MIL-PRF-19500/685
AMENDMENT 2
8 May 2002
SUPERSEDING
AMENDMENT 1
16 August 2001

PERFORMANCE SPECIFICATION

SEMICONDUCTOR DEVICE, FIELD EFFECT, RADIATION HARDENED
TRANSISTOR, N-CHANNEL SILICON TYPES 2N7475T1, 2N7476T1 AND 2N7477T1
(TOTAL DOSE AND SINGLE EVENT EFFECTS)
JANTXVR AND JANSR

FIGURE 3. Safe operating area graph."

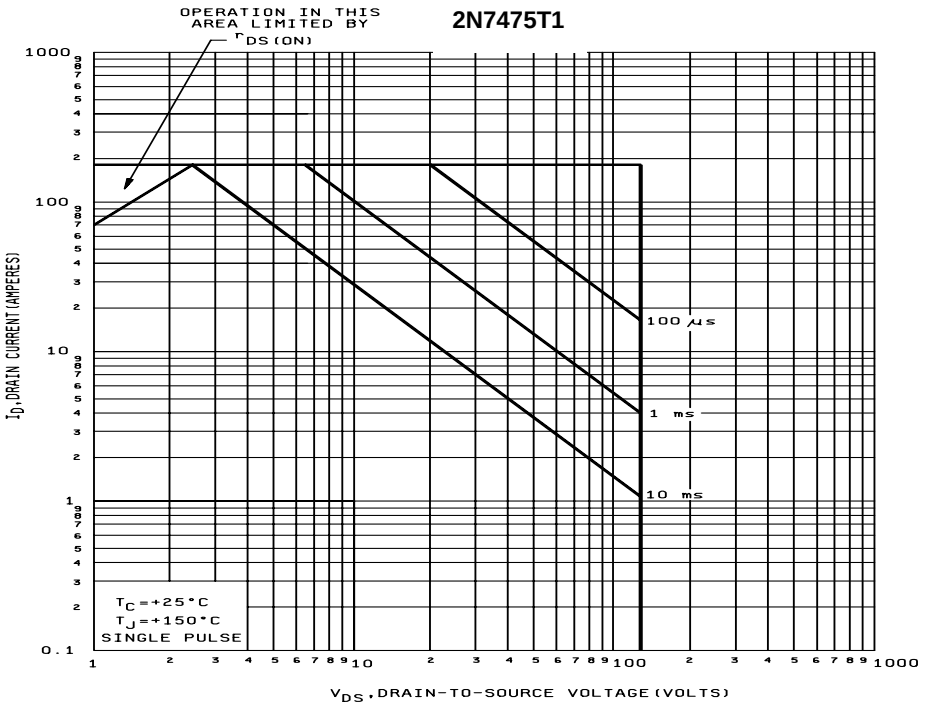
FIGURE 3, delete and substitute:

FIGURE 4. Safe operating area graph."

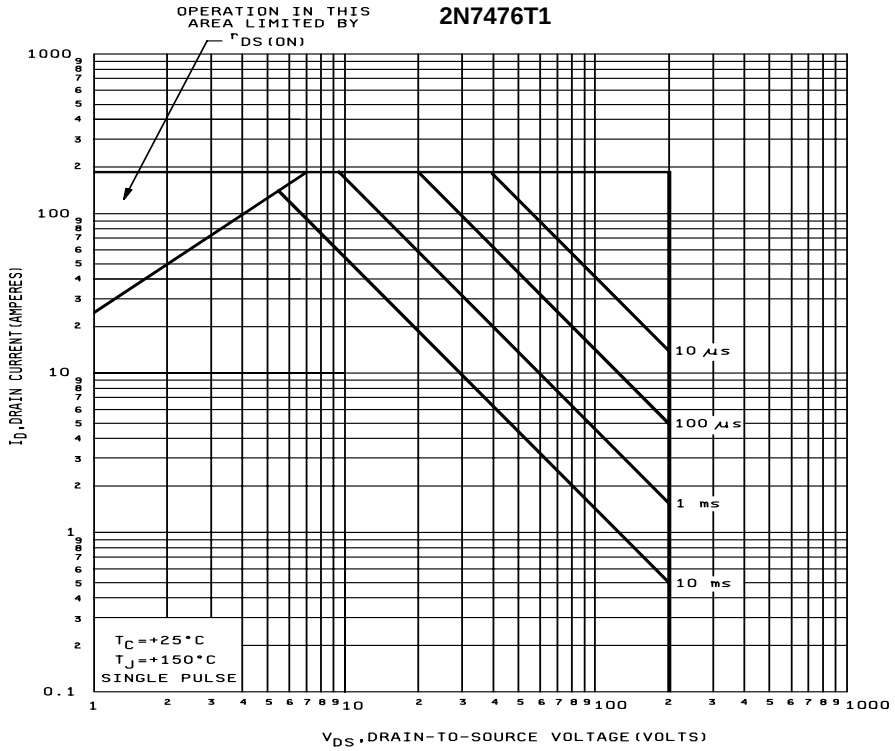
FIGURE 4, delete and substitute:

FIGURE 5. Safe operating area graph."

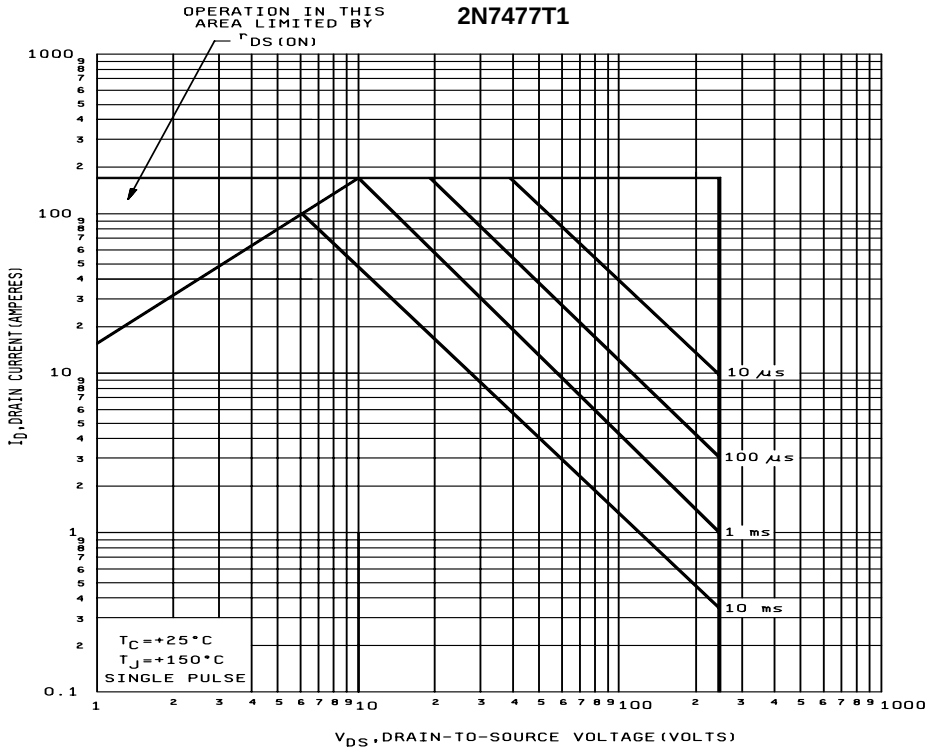
FIGURE 5, delete and substitute:
